October 6, 2020

Landis Hershey, Conservation Agent
Town of Walpole – Conservation Commission
135 School Street
Walpole, MA 02081

Re: **Proposed Multifamily Development – 55 Summer St Peer Review of Applicant's September 2020 Submission.**

APPLICANT: Detail below provided to Conservation Commission on sheet 69 of 86 on plan set dated 5/1/20 located via: https://www.walpole-ma.gov/sites/g/files/vyhlf1381/f/pages/plan_set_5-1-20.pdf

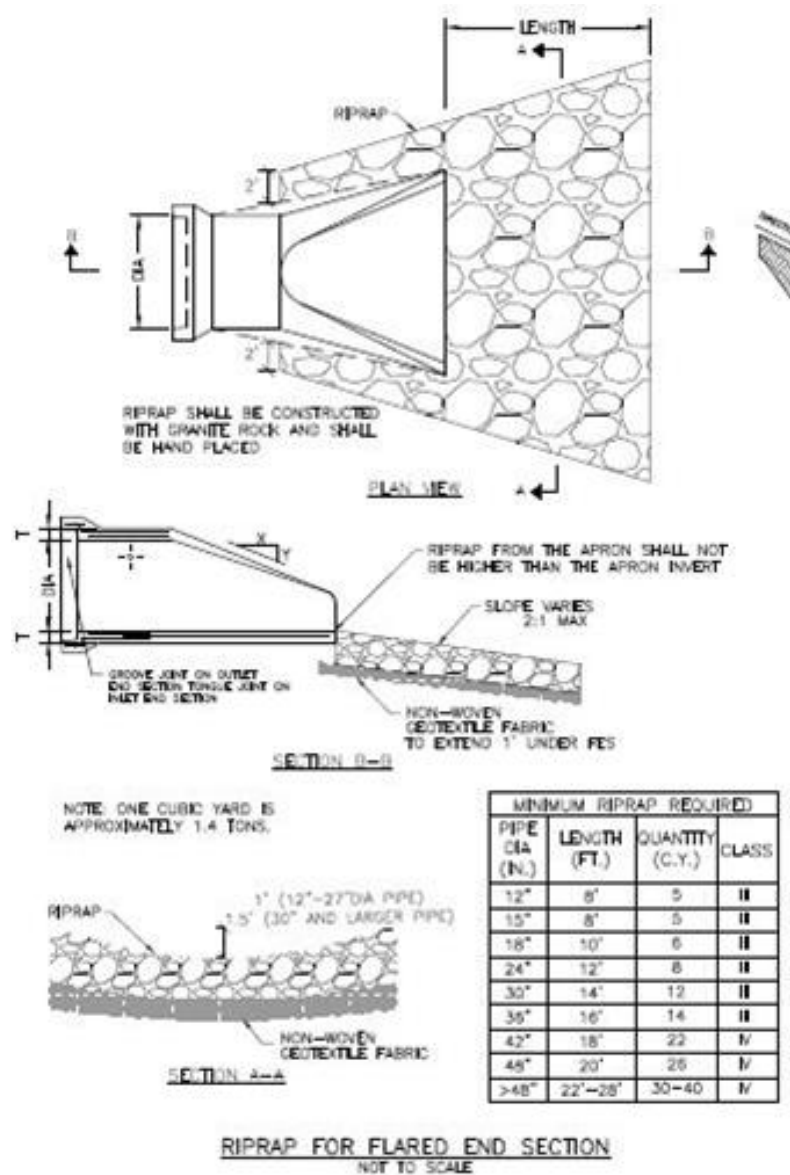
SW2. Provide calculations for sizing of riprap aprons to ensure that runoff will not cause erosion.

BETA: Provide calculations as requested to confirm.

HSH: Standard riprap aprons lengths and quantities for flared end sections has been provided on detail sheet 1 of 18 based on standard drainage pipe sizes. See detail sheet 1 of 18 (sheet 69 of 86) from the plan set dated 5/1/20.
